TOWN OF HORIZON CITY Planning and Zoning Commission Staff Report

Case No.: SDF23-0002

Rancho Desierto Bello Unit Fourteen (RDBU14)

Application Type: Final Plat

Attachment 4- RDB Unit 14 Final Plat

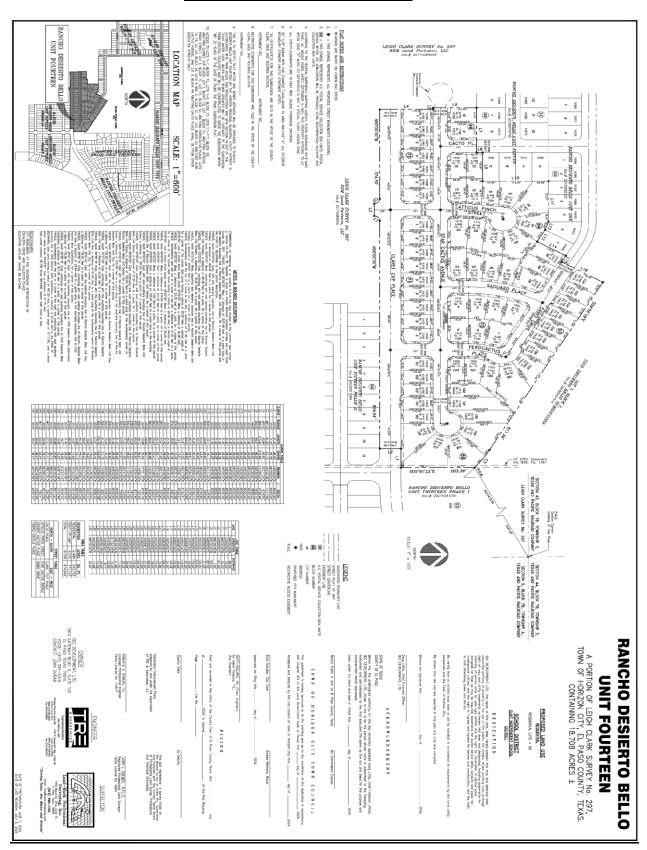
Please confirm and call out what instrument, timeline and surface improvement will be utilized to provide temporary turnaround easements on property outside subject subdivision? (To be addressed prior to recording)

- 1. Show Ferro Cactus as two words on plat as per street table.
- 2. Provide Closure with metes and bounds description (on final plat).
- 3. Address review/approval by the El Paso County 9-1-1 District is required.
- 4. Blocks 34,53,72 (EAST AND WEST SIDE), address numbers shall be 3 DIGITS (see section 107.090

ORDINANCE 00107).

Provide explanation for the 4 digits provided, is this a request from El Paso County 9-1-1 District? Provide email/

approval on final plat

- 1. Provide closure reports for the subdivision and the individual lot to ensure closure.
- 2."Saguaro Place" not on Street Table. Update Street Table to include.
- 3. "Desert Cactus Place" is no longer on plat, but on Street Table. Update Plat and table with correct street names.
- 4. See Town of Horizon for additional comments.
